Office Action Summary	Application No. 10/603,471	Applicant(s) GAUSE ET AL.	
	Examiner Anu Ramana	Art Unit 3775

DETAILED ACTION

to be persuasive because Coates et al. discloses all elements of Applicant's claimed invention as illustrated in marked up Fig. 17 of Coates et al. (see following page).

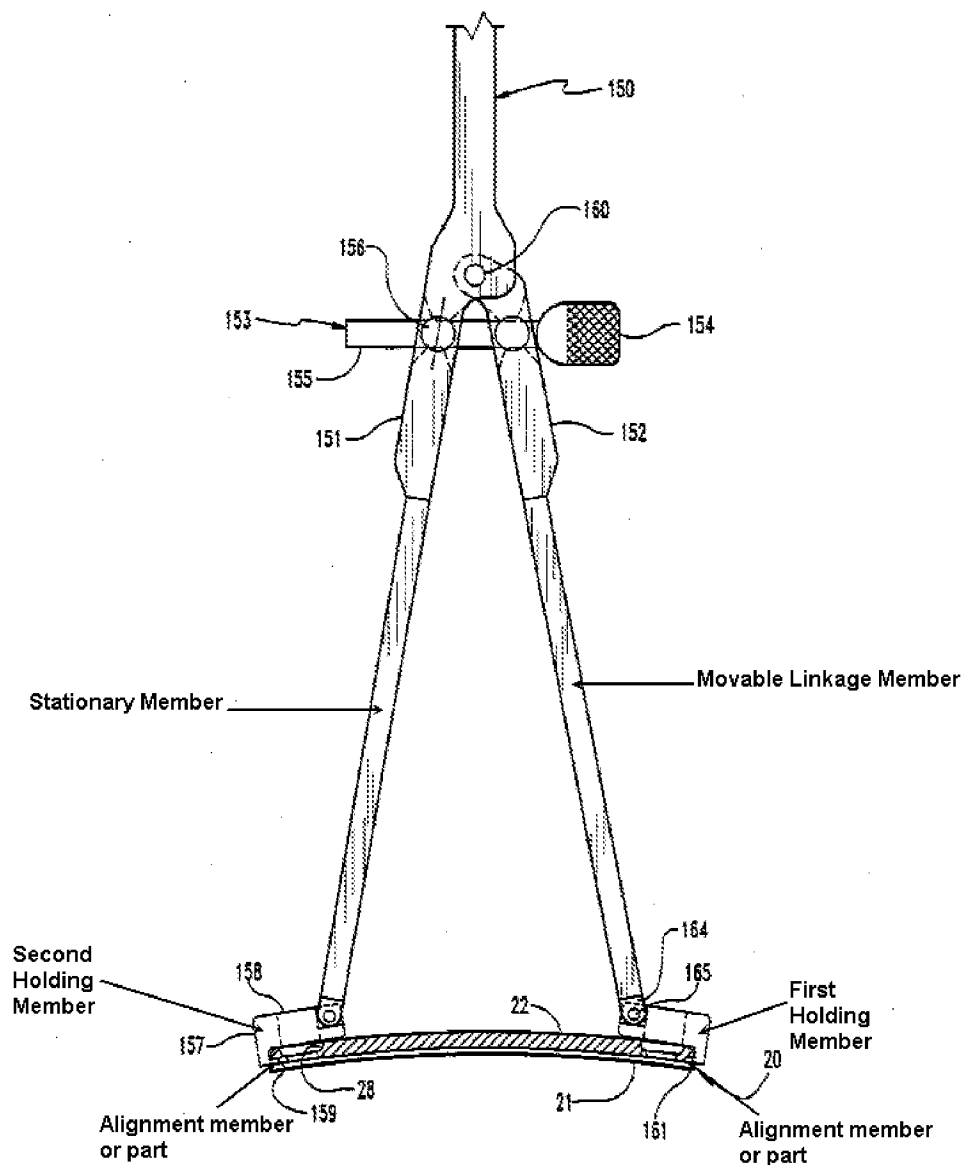
Applicant's arguments with respect to the rejections of claims 36-38 under 35 USC 102(b) over Coates et al. (US 5,423,826) have been considered but are not found

Guide member 180 is mounted to the stationary member when received in the second holding member. It is noted that Applicant is not claiming the guide member to be directly mounted to the stationary member. It is the Examiner's position that the recitation "mounted proximally of said holding system" only requires a portion of the guide member to be proximal to the holding system, i.e., the first and second holding members. The recitation "to guide placement of a bone-engaging fastener" is functional and only requires guide member 180 to be capable of receiving a bone fastener. In order to be given patentable weight, a functional recitation must be supported by recitation in the claim of sufficient structure to warrant the presence of the functional language. In re Fuller, 1929 C.D. 172; 388 O.G. 279.
